INFORMATION

ALTERNATION OF LEAD WIRE'S THICKNESS (AVR-512 / AVR-580 / AVR-593)

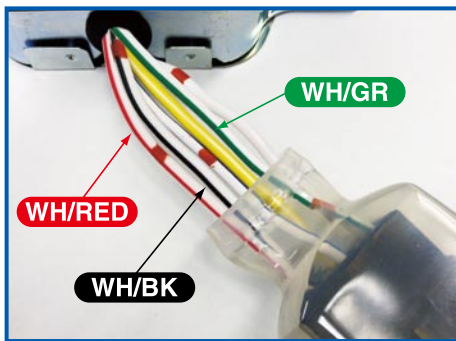
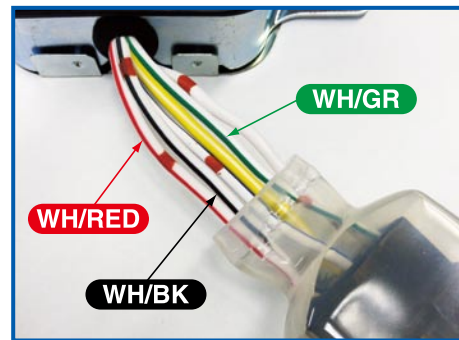
EACH SIZE 0.5mm²

EACH SIZE 1.25mm²
